**Planning Board Meeting
September 17, 2018
Minutes**

CD18-01 – Discussion and Action on a Request to Create an R-3 Conditional District for property located at 1320 S. Hollybrook Rd.

Phasing:

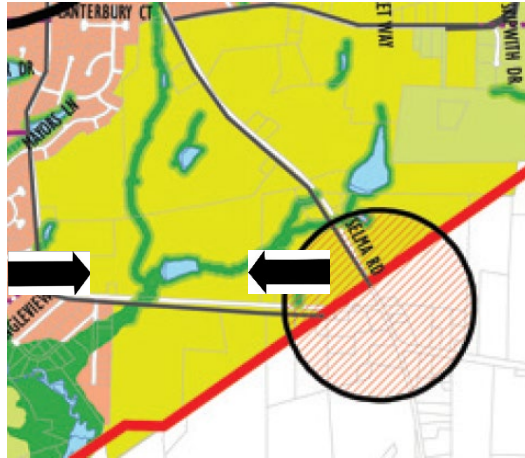
David Bergmark said staff was concerned that the phasing plan showed the amenity center not being required until AFTER Phase 3. He said staff would prefer to see the active amenity site be installed PRIOR to phase 3.

The Developer said that they hoped to get the amenity site installed before then, but they didn't want to be contractually obligated to it. The Developer said he was looking for flexibility and to allow the market to dictate when the amenity site is installed. He said that the residents would have access to the amenity sites at other Fred Smith subdivisions.
